# BCA 2022 AMENDMENT 2 CAPABILITY REPORT FOR SSDA SUBMISSION

<b>CLIENT:</b>	TQM
<b>PROJECT NAME:</b>	LOTUS, HURSTVILLE MIXED USE DEVELOPMENT
<b>PROJECT ADDRESS:</b>	105 FOREST ROAD & 1A HILL ST, HURSTVILLE NSW 2220
<b>DATE:</b>	10 SEPTEMBER 2025
<b>PROJECT NO:</b>	250343

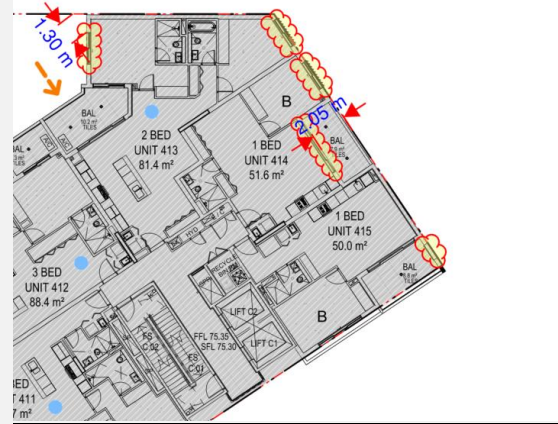
<p>2.</p>	<p>C3D13 C3D14</p>	<p>The switch room must be fire separated achieving an FRL of 120/120/120 with doorways protected with a self-closing fire door achieving an FRL of --/120/30.</p> <p>This also applies to the comms rooms if it sustains emergency equipment operating in the emergency mode.</p>	<p>The architect is to confirm compliance with the requirements of this clause.</p> <p>It is in the opinion of this office that compliance with the requirements of this clause can be achieved.</p>
<p>3.</p>	<p>C4D3 C4D5</p>	<p><u>Levels 1 -9:</u> The openings clouded in yellow are within 3m of the side/rear boundary and require protection in accordance with C4D5 or, alternatively a performance solution is to be provided.</p> <p><i>Level 1</i></p>  <p><i>Level 2 (Level 3 reflected)</i></p>  <p><i>Level 4</i></p>	<p>Updated plans demonstrating compliance are to be provided or, alternatively, a performance solution by the Fire Safety Engineer will be required to address these non-compliances.</p>

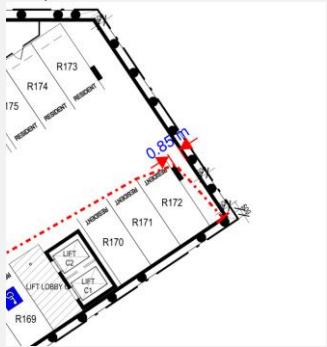
<p>6.</p>	<p>Specification 5</p>	<p><u>Residential Levels:</u> The bounding wall separation detail at the external wall is to be provided once coordination with the facade engineer has been finalised. Where compliance with clause C4D12 and Spec. 5 is not provided, a performance solution will be required.</p>		<p>The design team is to provide the required information. Any required performance solution will be provided at the construction certificate stage.</p>

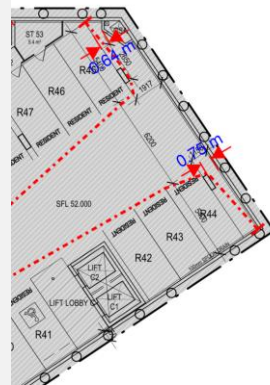
<p>7.</p>	<p>D2D8</p>	<p><b>Basement Level 4:</b> A 1000mm unobstructed width is required along the path of travel to an exit. 850mm width is identified on the plans.</p>  <p><b>Basement Level 3:</b> A 1000mm unobstructed width is required along the path of travel to an exit. 640mm and 750mm widths are identified on the plans.</p>  <p><b>Basement Level 2:</b> A 1000mm unobstructed width is required along the path of travel to an exit. 640mm and 750mm widths are identified on the plans.</p>	<p>Updated plans demonstrating compliance are to be provided or, alternatively, a performance solution by the Fire Safety Engineer will be required to address these non-compliances.</p>
-----------	-------------	---	---

**Basement Level 1:**

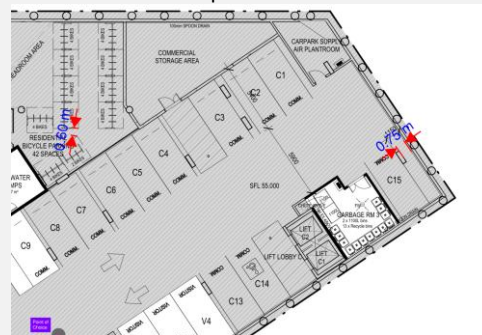
A 1000mm unobstructed width is required along the path of travel to an exit. 600mm and 750mm widths are identified on the plans.

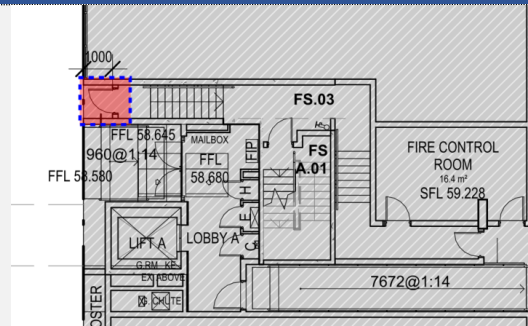
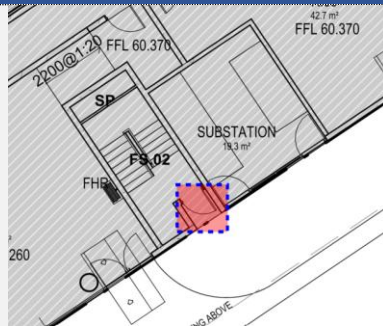
Ground Floor Level: The walls adjacent to the discharge points of the fire-isolated stairs (FS.02 and FS.03) are to have an FRL of not less than 60/60/60.

The architect is to confirm compliance with the requirements of this clause.

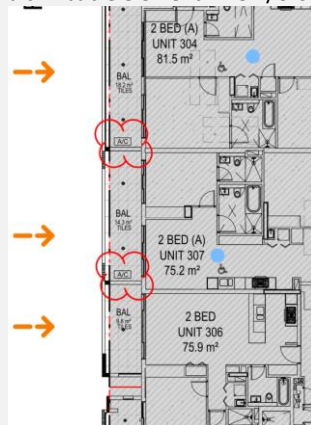
**Balconies - Residential units:** The location of the condenser unit in proximity to the balustrade is considered a climbable element. The A/C is to be relocated or enclosed in a non-climbable enclosure.

The architect is to confirm compliance with the requirements of this clause.

**Levels 3 – 6 - Fire-Isolated Stairway FS A.01:**

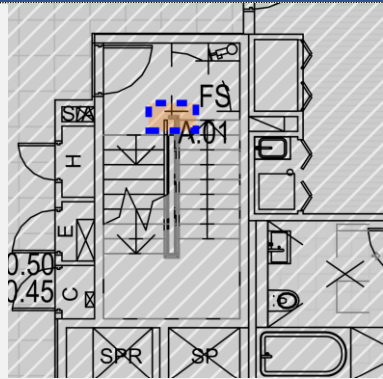
The handrail is to be continuous between stair flights in accordance with the requirements of this clause.  
 Note: Figure below is of Level 3 only – The non-compliance is reflected in levels 4-6.

The architect is to confirm compliance with the requirements of this clause.

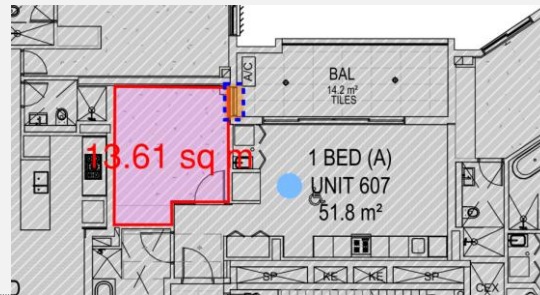
Confirmation is required that the natural light transmitting area of the window facing the balcony in the following units is not less than 10% of the floor area of the room in accordance with the requirements of this clause:

- a) Level 4 Unit 407 bedroom: The required that the natural light transmitting area of the window is 1.376m<sup>2</sup>

The architect is to confirm compliance with the requirements of this clause or alternatively, a performance solution can be provided by AllCert.

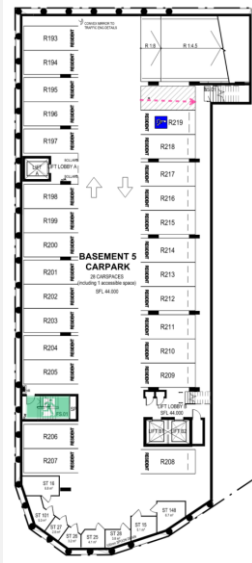
4.	D2D3	<p>As the building has an effective height of more than 25m, a minimum of two (2) exits are required to serve each storey. Concessions apply in D2D3(2)(b). Based on our review of the plans, the following parts of the building are provided with only one (1) exit in lieu of two (2):</p> <p><u>Basement Level 5:</u> Only 1 exit is provided. Note: the stairway leading to Basement Level 4 is not considered an exit as it does not provide egress to open space or the road.</p>	A performance solution by the Fire Safety Engineer will be required to address these non-compliances.

Levels 2 – 7:

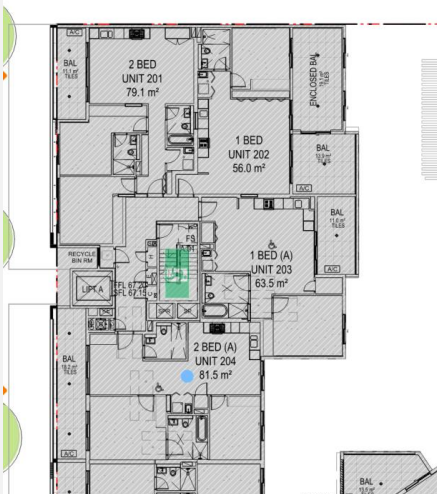
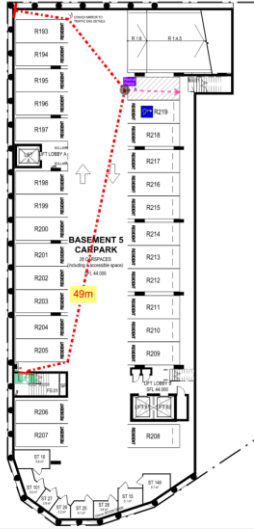
Only 1 exit is provided. Refer to the figure below showing the single exit design on Level 2.

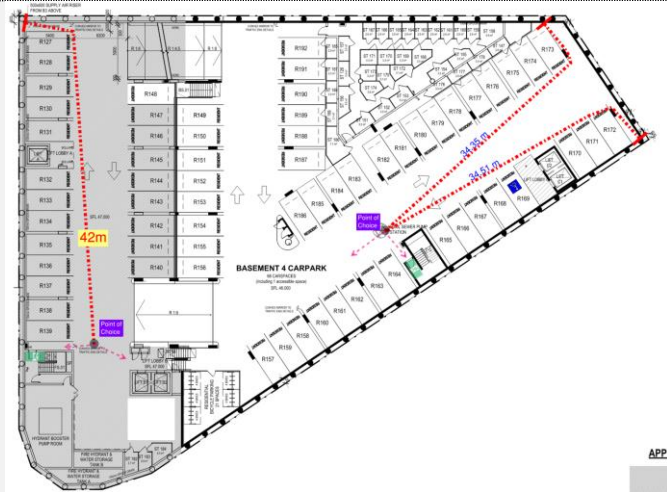
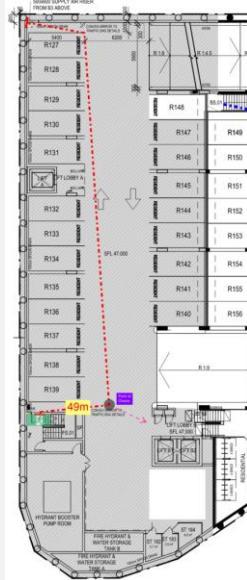
<p>5.</p>	<p>D2D5</p>	<p>The following extended travel distances have been identified:</p> <p><b>Basement Level 5:</b>          Extended travel distance is measured up to 49m in lieu of 40m to an exit.</p>  <p><b>Basement Level 4:</b>          a) Extended travel distance is measured up to 42m in lieu of 20m to a point of choice.</p>	<p>A performance solution by the Fire Safety Engineer will be required to address these non-compliances.</p>
-----------	-------------	---	--

b) Extended travel distance is measured up to 49m in lieu of 40m to an exit.

Basement Level 3:

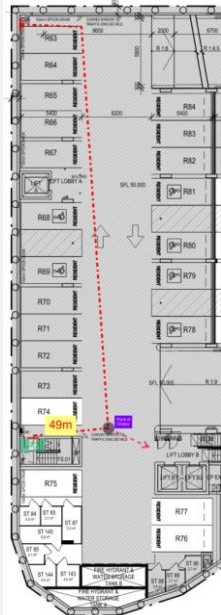
a) Extended travel distance is measured up to 42m in lieu of 20m to a point of choice.

b) Extended travel distance is measured up to 49m in lieu of 40m to an exit.

Basement Level 2:

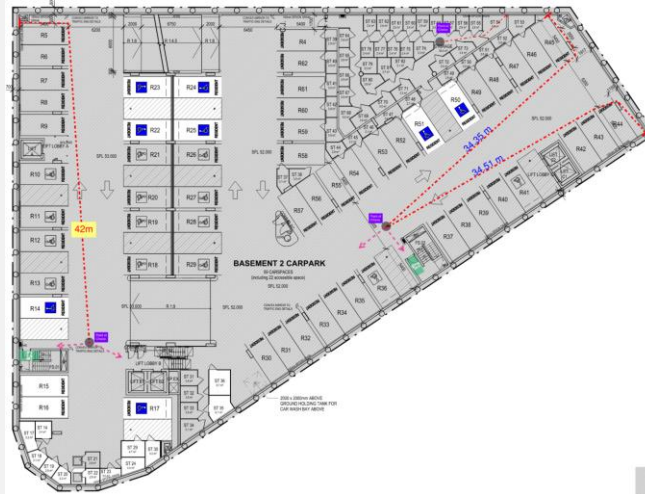
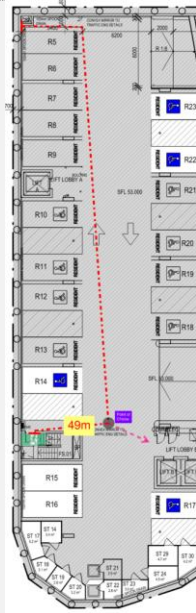
a) Extended travel distance is measured up to 42m in lieu of 20m to a point of choice.

b) Extended travel distance is measured up to 49m in lieu of 40m to an exit

**Levels 1 – 6:**

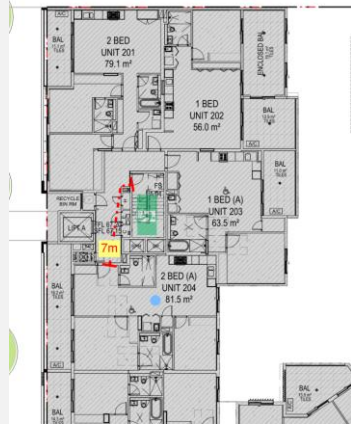
Extended travel distance of up to 7m in lieu of 6m to an exit.

Note: Figure below is of Level 1 only – The non-compliance is reflected in levels 2-6.

Level 1:

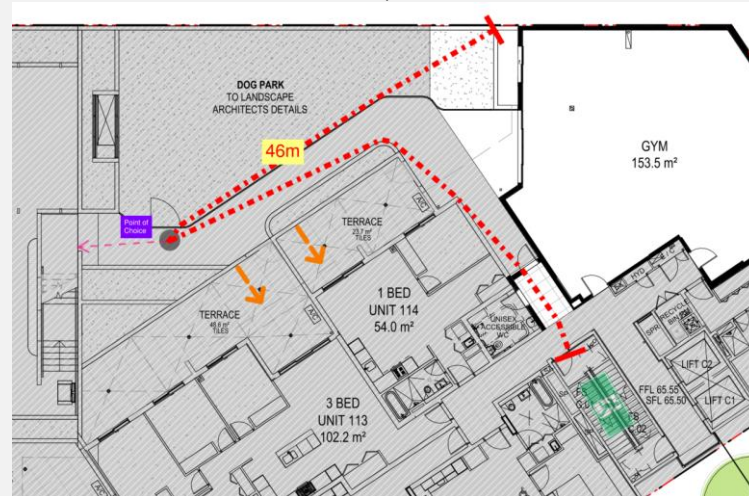
Extended travel distance is measured up to 46m in lieu of 20m to an exit.

**Basement Level 4:**

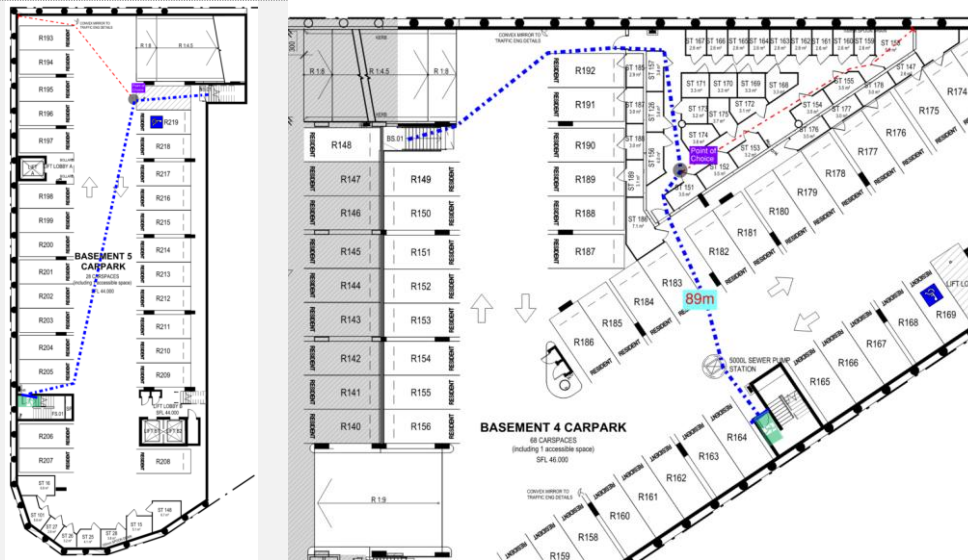
Distance between alternative exits (FS.02 on Basement level 4 and FS.01 on basement level 5) is measured up to 89m in lieu of 60m.

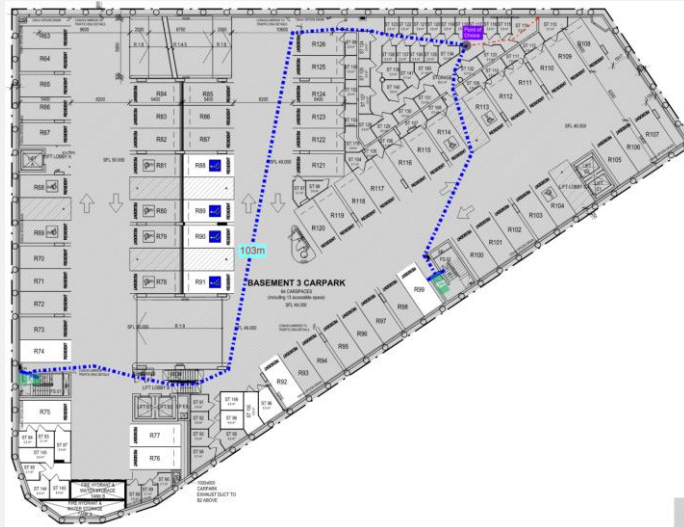
Basement Level 3:  
Distance between alternative exits is measured up to 103m in lieu of 60m.

**Basement Level 2:**

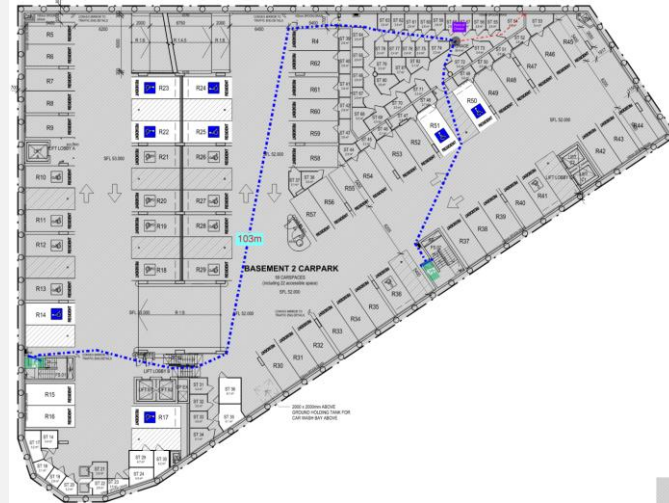
Distance between alternative exits is measured up to 103m in lieu of 60m.

**Basement Level 1:**

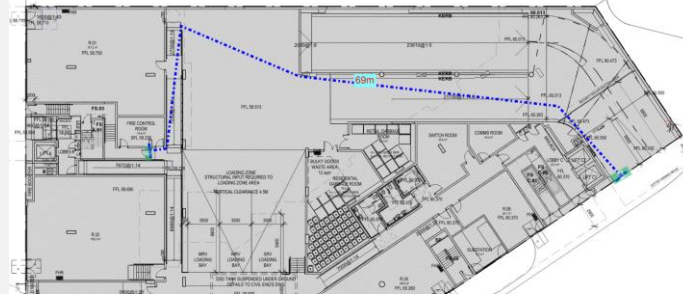
Distance between alternative exits is measured up to 78m in lieu of 60m.

Level 1:

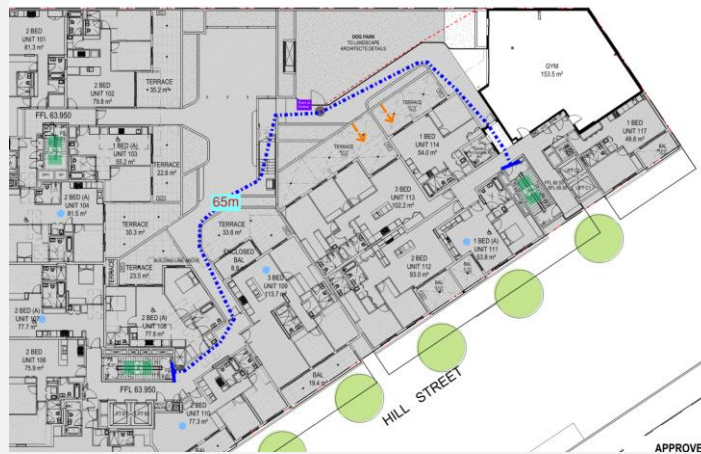
Distance between alternative exits is measured up to 65m in lieu of 45m.

**Roof Terrace:**

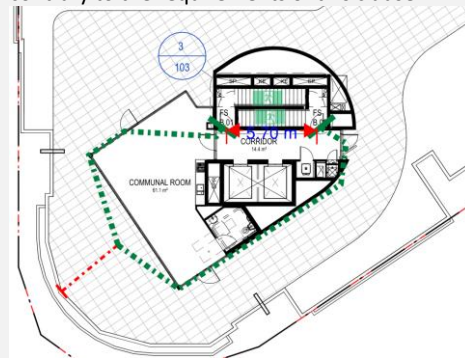
The plans show the alternative paths of travel from the roof terrace converge to become less than 6m apart, contrary to the requirements of this clause.

**Levels 2 – 10 - Fire Stairways FS C.01 and FS C.02:**

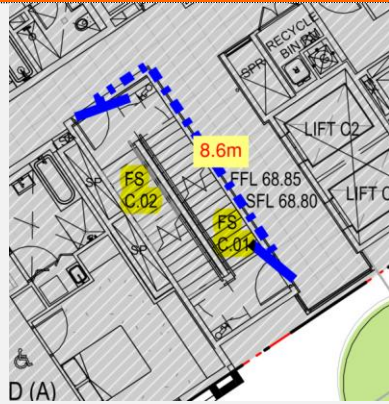
The plans identify the distance between the alternative exits FS C.01 and FS C.02 is 8.6m, contrary to the requirements of this clause.

Note: Figure below is of Level 2 only – The non-compliance is reflected in levels 3-10.

A performance solution by the Fire Safety Engineer will be required to address this technical non-compliance.

Roof Terrace – Fire Stairways FS B.01 and FS B.02:

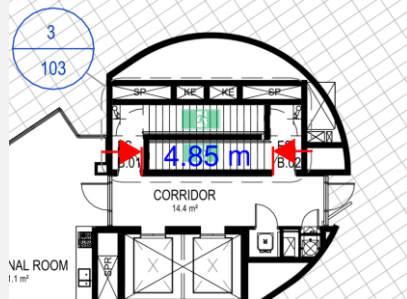
The plans identify the distance between the alternative exits FS B.01 and FS B.02 is 4.85m approximately, contrary to the requirements of this clause.

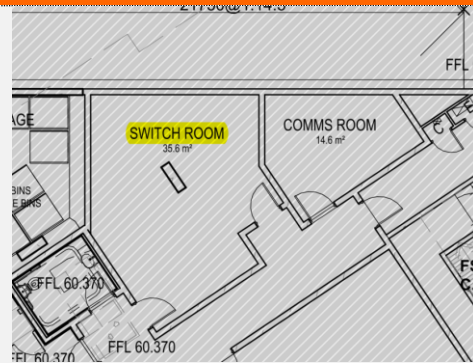
9.	D2D12(2)	<p><b>Ground Floor level:</b> The fire stairs FS A.01 and FS.03 as well as FS B.01 and FS B.02 from the residential levels do not provide independent egress from each storey served by their own way of its own fire-isolated passageway to the road or open space, contrary to the requirements of D2D12(2). The fire isolated passageway of FS A.01 is combined with FS.03 and the fire isolated passageway for FS B.01 is combined with FS B.02.</p>	<p>A performance solution by the Fire Safety Engineer will be required to address these non-compliances.</p>
----	----------	--	--

Ground Floor Level – Fire Control Room:

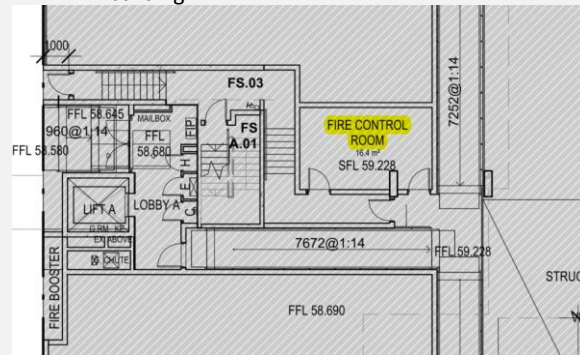
- a) S19C4 – Location of fire control centre: A fire control centre must be located in a building that egress from any part of its floor, to a road or open space, does not involve changes in level which in aggregate exceed 300 mm. Egress from one of the fire control doors leads into FS.03 which includes stairways to reach the road. This is contrary to the requirements of this clause
- b) S19C9 – Doors to a fire control room: The doors to the fire control room must open into the room, be lockable and located so that persons using escape routes from the building will not obstruct or hinder access to the room.
- c) S19C9 – Doors to a fire control room: The fire control room must be accessible from the front entrance of the building. The fire control room is not accessible for the front entrance of the building.

A performance solution by the Fire Safety Engineer will be required to address these non-compliances.

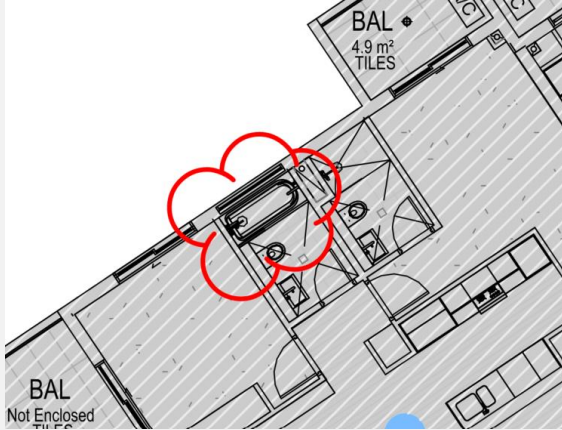
<p>16.</p>	<p>F2D2</p>	<p><u>Levels 6 - 9 - Bathrooms:</u>            Confirmation is required if there is a combined bath and shower within the bathroom in the units listed below. If confirmed, a performance solution is required for any window opening within the combined bath and shower area.</p> <ul style="list-style-type: none"> <li>• Unit 612, 712, 812 and 912</li> </ul> <p>Note: Figure below is Unit 612 only – The non-compliance is reflected in the other units noted.</p> 	<p>A performance solution by the waterproofing consultant is to be provided to address this non-compliance.</p>
------------	-------------	--	---
